**From:** [REDACTED]  
**Sent:** Friday, December 5, 2025 5:59 PM  
**To:** tpbpd/PLAND <[tpbpd@pland.gov.hk](mailto:tpbpd@pland.gov.hk)>  
**Cc:** Kanic Chung Kit KWOK/PLAND <[kckkwok@pland.gov.hk](mailto:kckkwok@pland.gov.hk)>  
**Subject:** A/YL-HTF/1198

就上述檔案，現提交補充資料以回應部門意見。

## 美化環境建議計劃圖

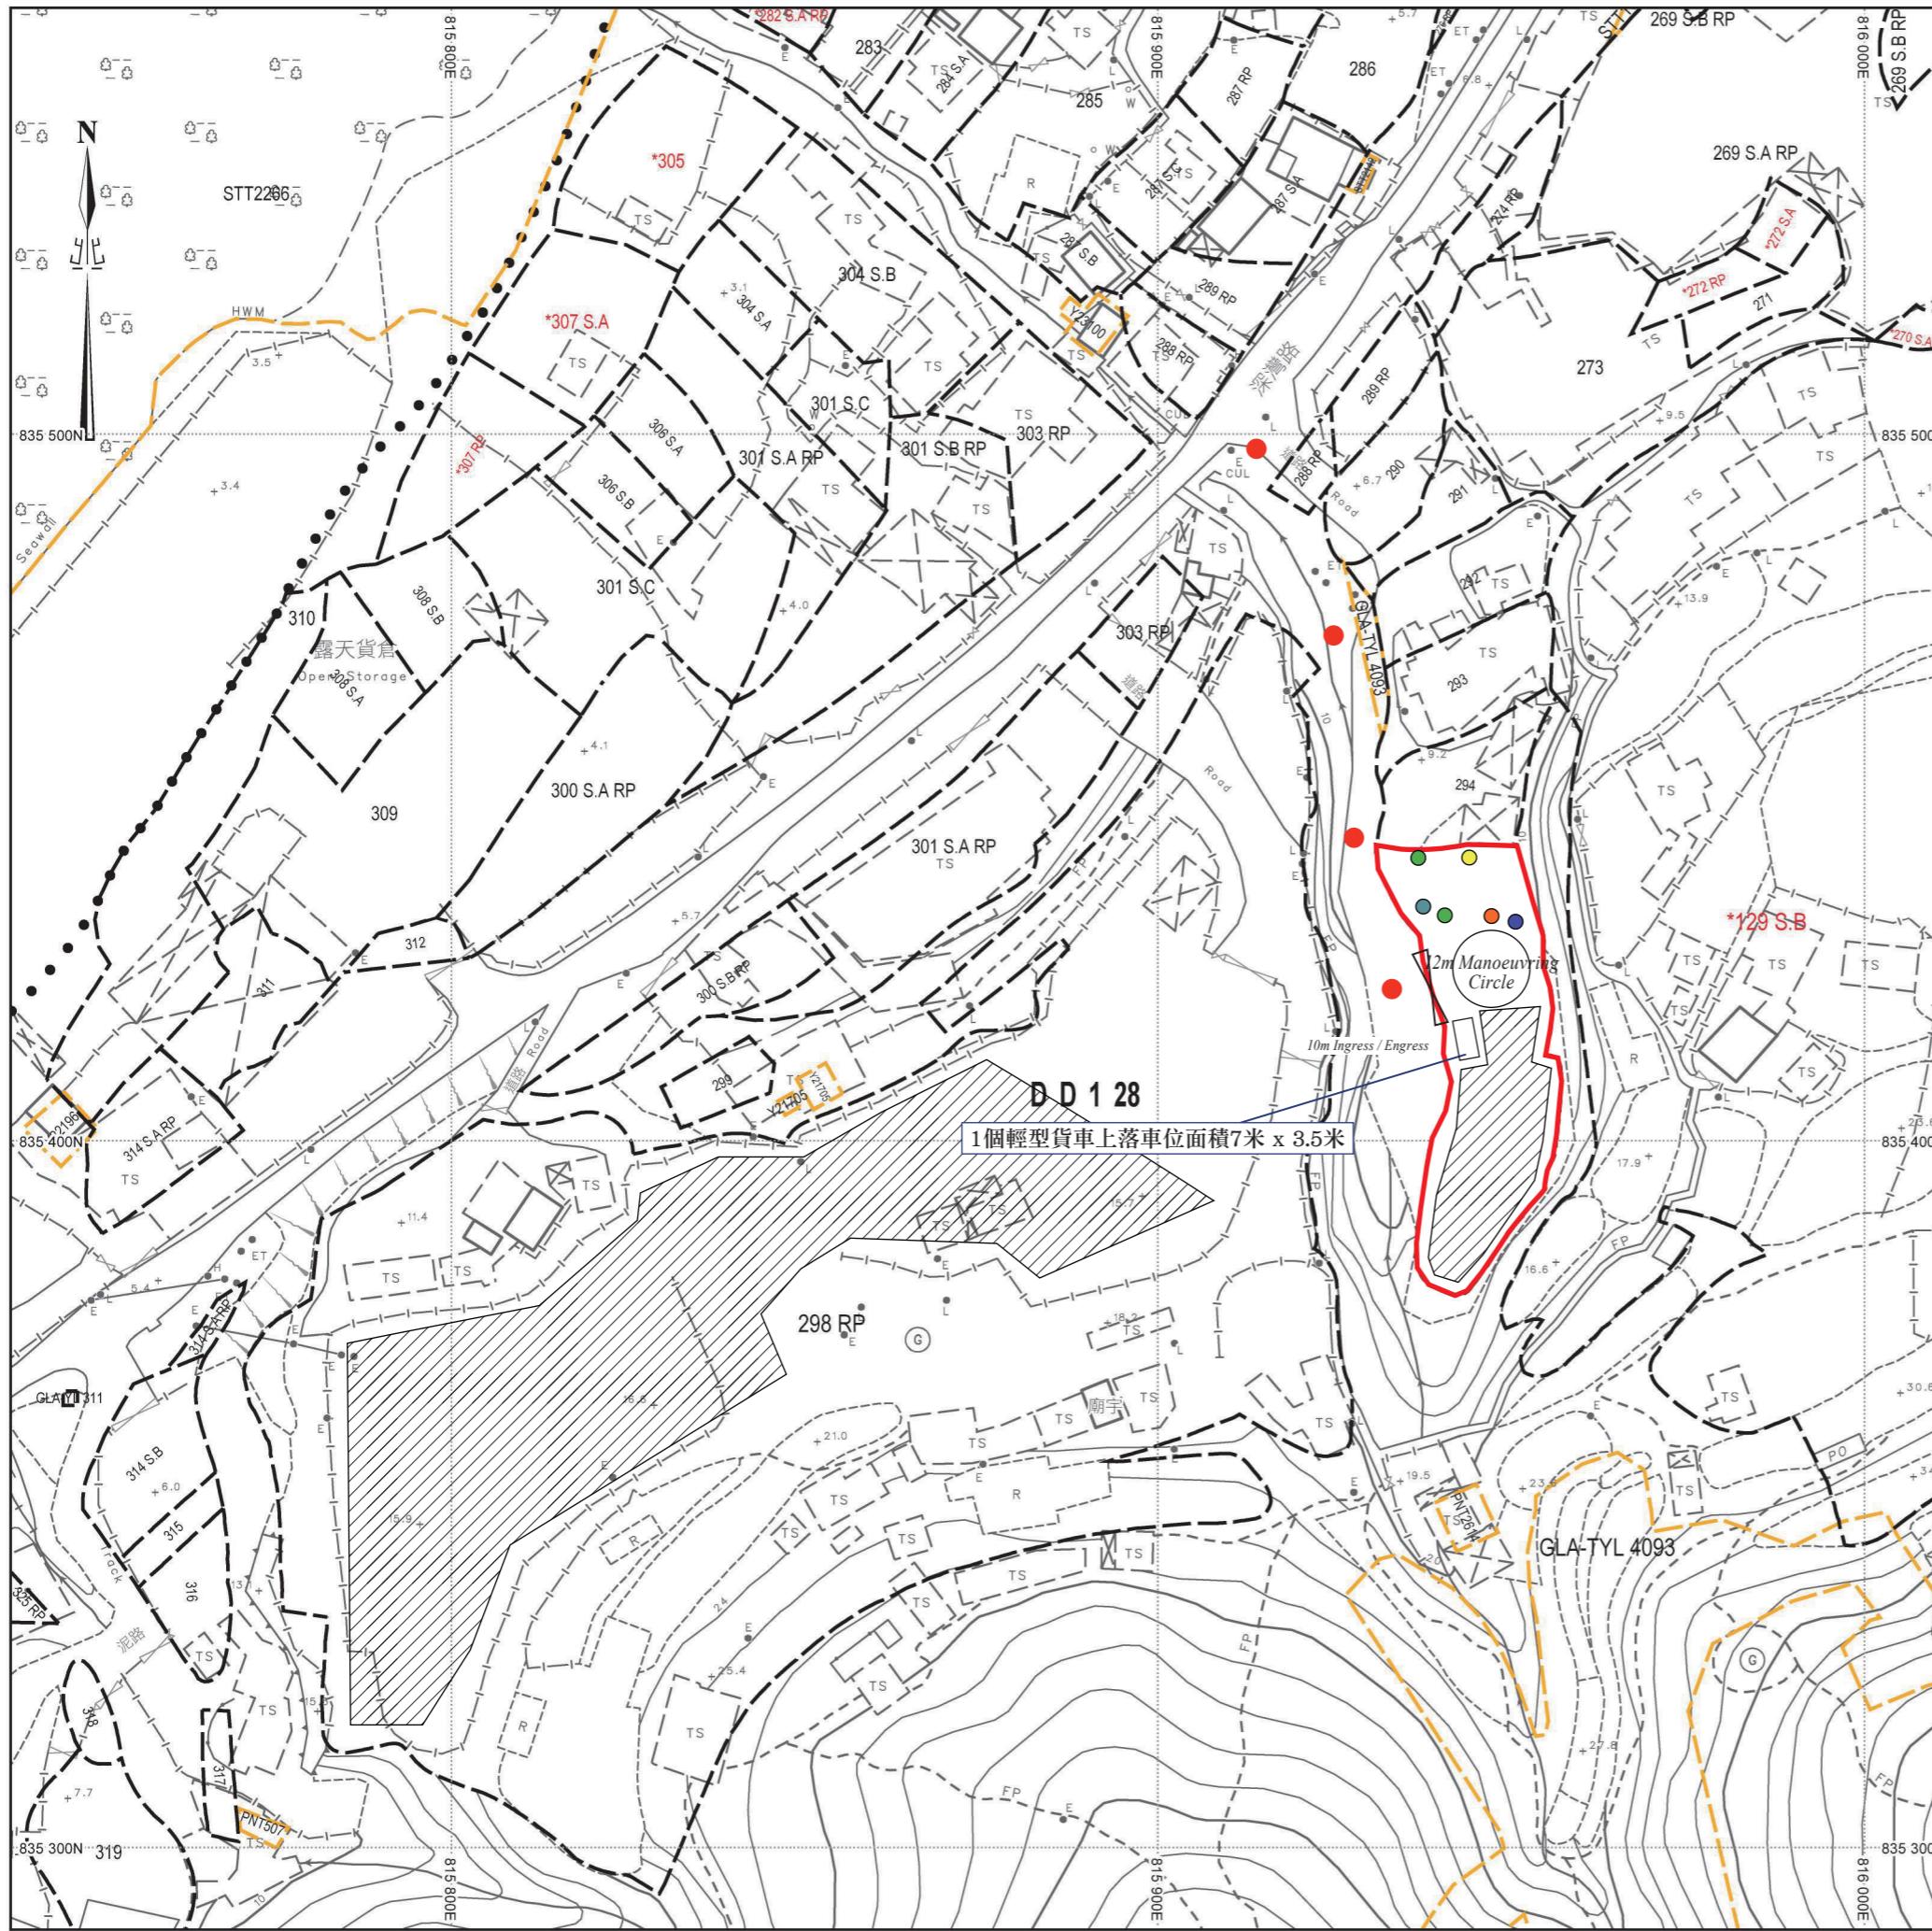
有關美化環境建議計劃，申請人承諾會保育及保護現有6棵樹木，包括：1棵松樹、2棵荔枝樹、1棵芒果樹、1棵香蕉樹、1棵龍眼樹。(可參閱美化環境及保護樹木建議圖)

申請人已得悉有關事宜，明白申請地點附近的斜坡對構築物及安全或會有影響，我們亦為此作出修改，場地不設任何構築物，只作露天存放建築材料。(可參閱場地設計圖)

場地不會設置任何構築物，只作露天存放建築材料，露天存放建築材料面積約426平方米。

排水系統方面，場地需進行挖土以完成渠務工程，但整個申請場地已進行了填土工程，升高約0.2米，故排水渠的挖地工程並不會影響地面，因此申請並不會對周圍環境及考古價值造成影響。
